INVITATION TO BID NO. 21-DPR-ITB-673

ADDENDUM NO. 2

Arlington County Invitation to Bid No. 21-DPR-ITB-673 for Construction of Thomas Jefferson Upper Field Turf Conversion is amended as follows:

TS-SS1232-3P-02-CL

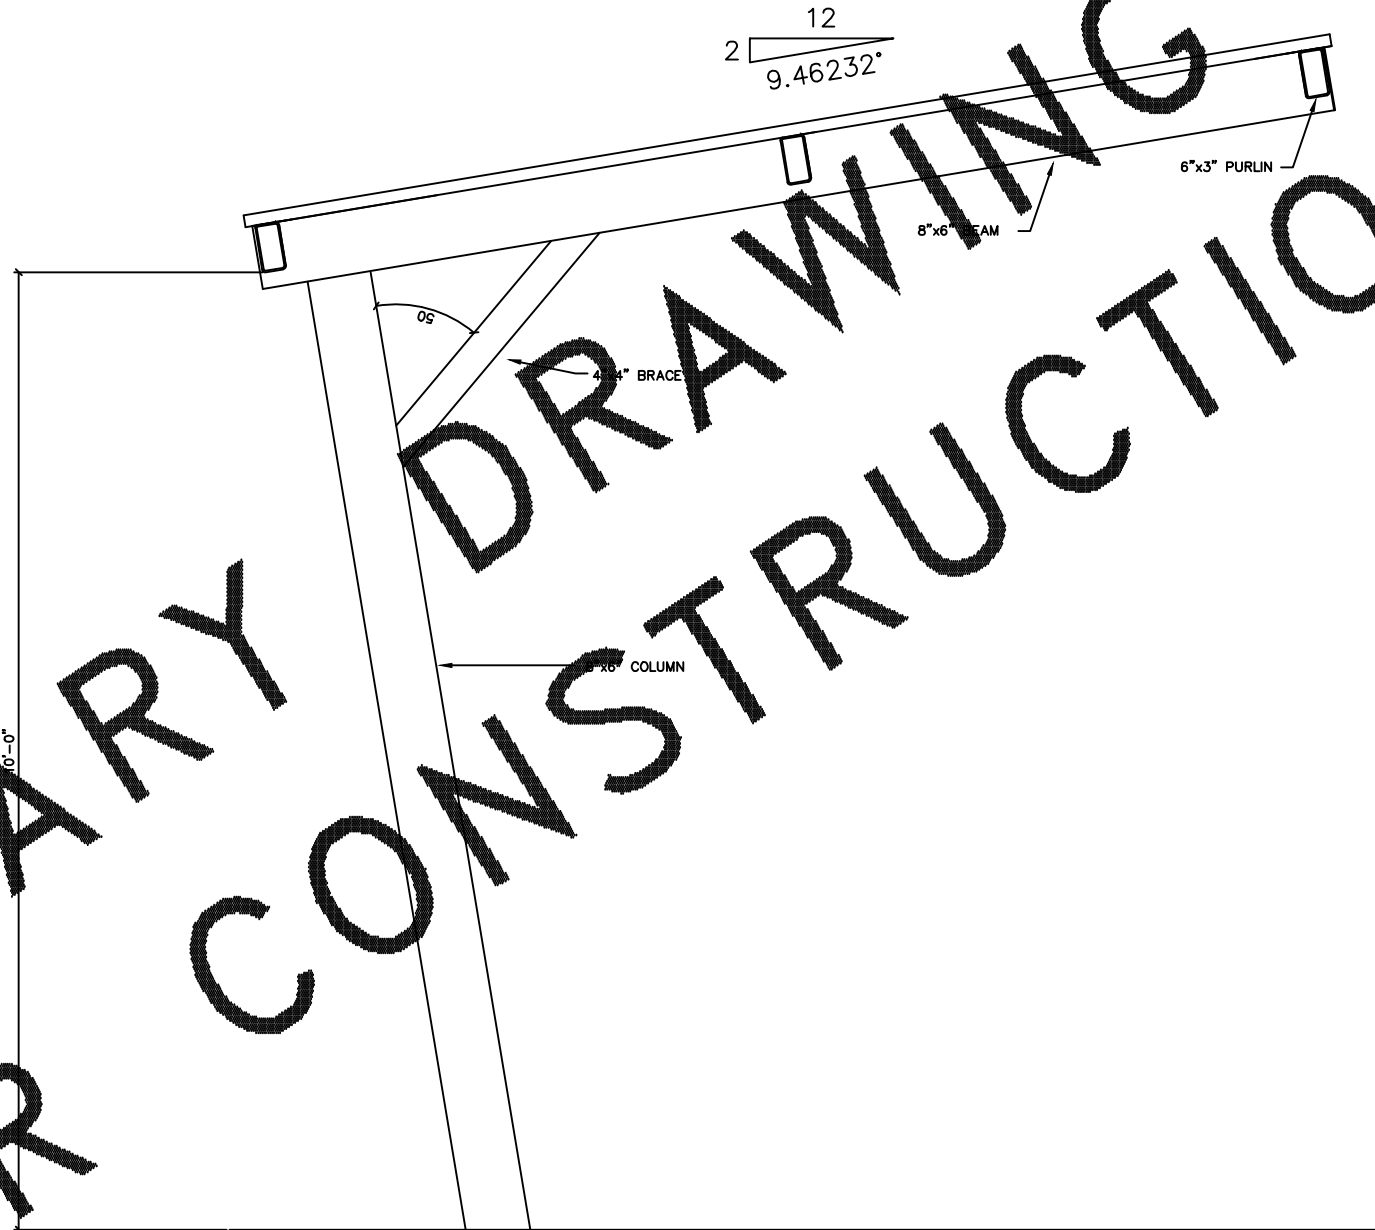
1. **Question: Please approve RCP Shelters as an approved equal for 11'-6" x 32' Steel Single Slope Cantilever Shelter?**

Answer: RCP Shelter is approved per attached shop drawing and specifications (Attachment A - TS-SS1232-3P-02-CL-Z-Model.pdf and Attachment B - RCP Shelters 3-Part Spec - AS # 35164.pdf). General contractor shall obtain the building permit as stipulated in 133419 1.06B.

C-04
SHEET 04 OF 42

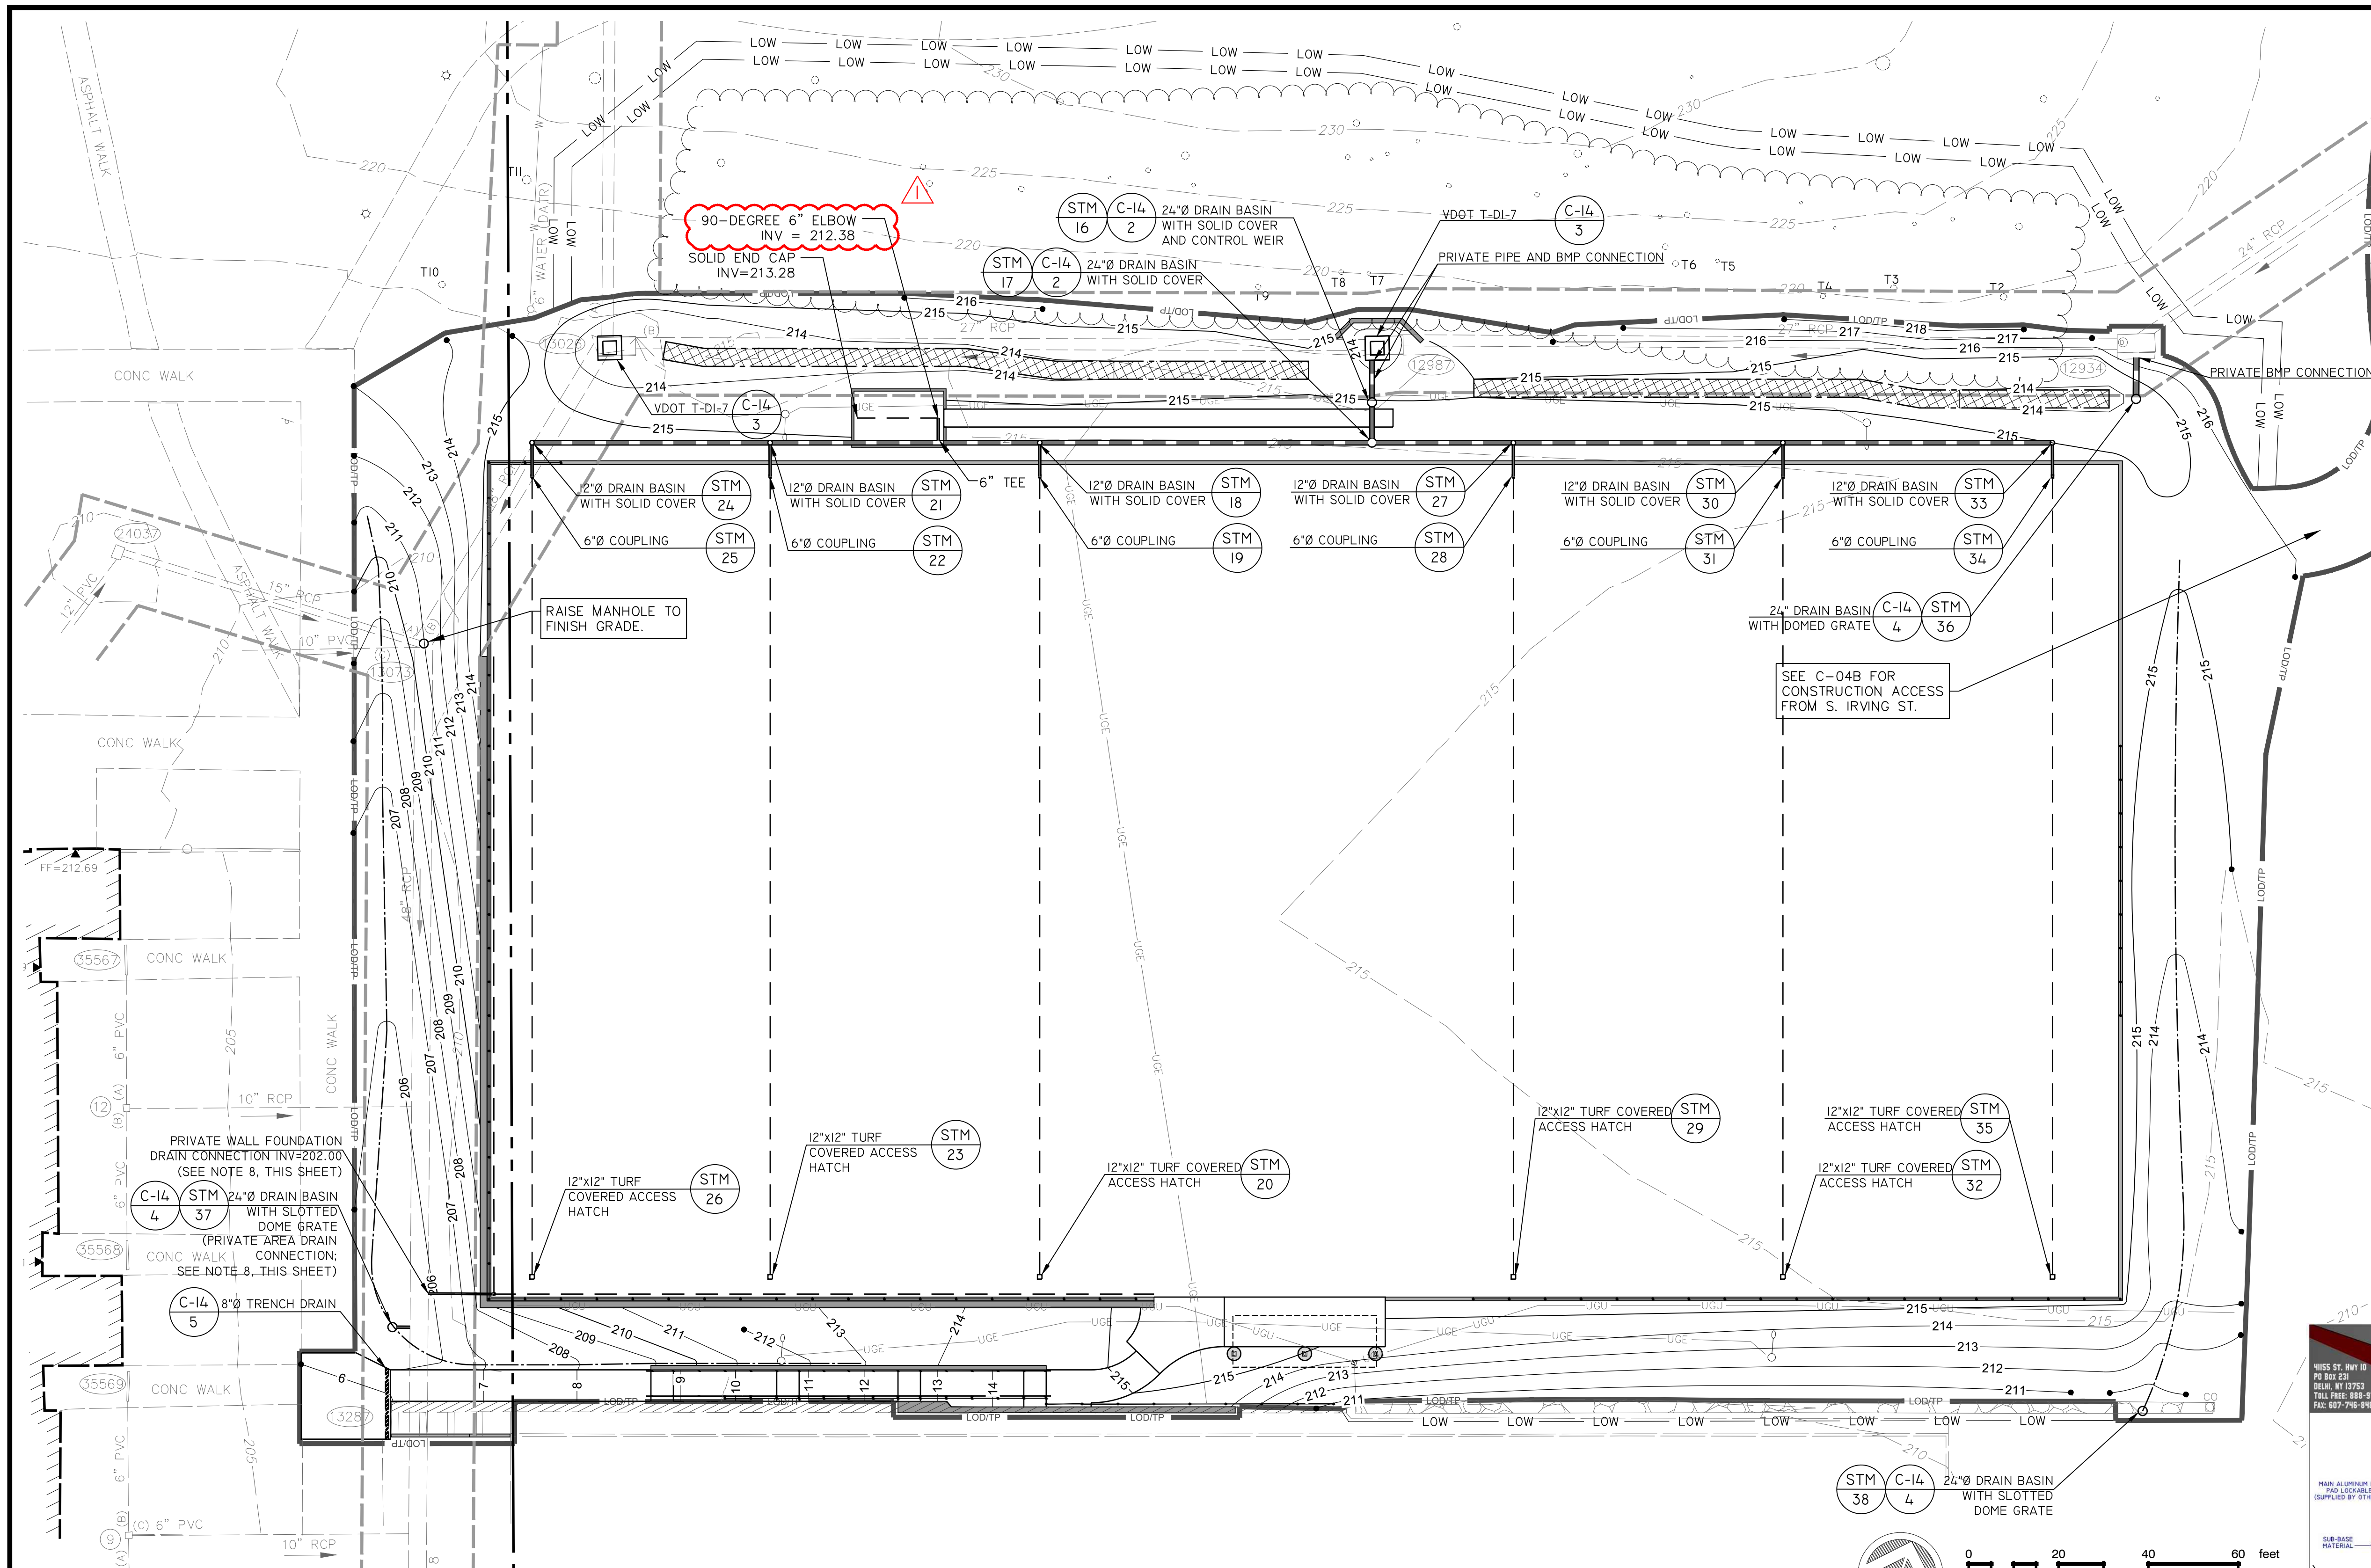
5. **Question: Drawing C04 states to remove the existing irrigation lines. Please provide the drawing to show the existing irrigation systems.**

Answer: Record drawings for the irrigation design are not available. The irrigation mainline is believed to enter the upper field from the east side.
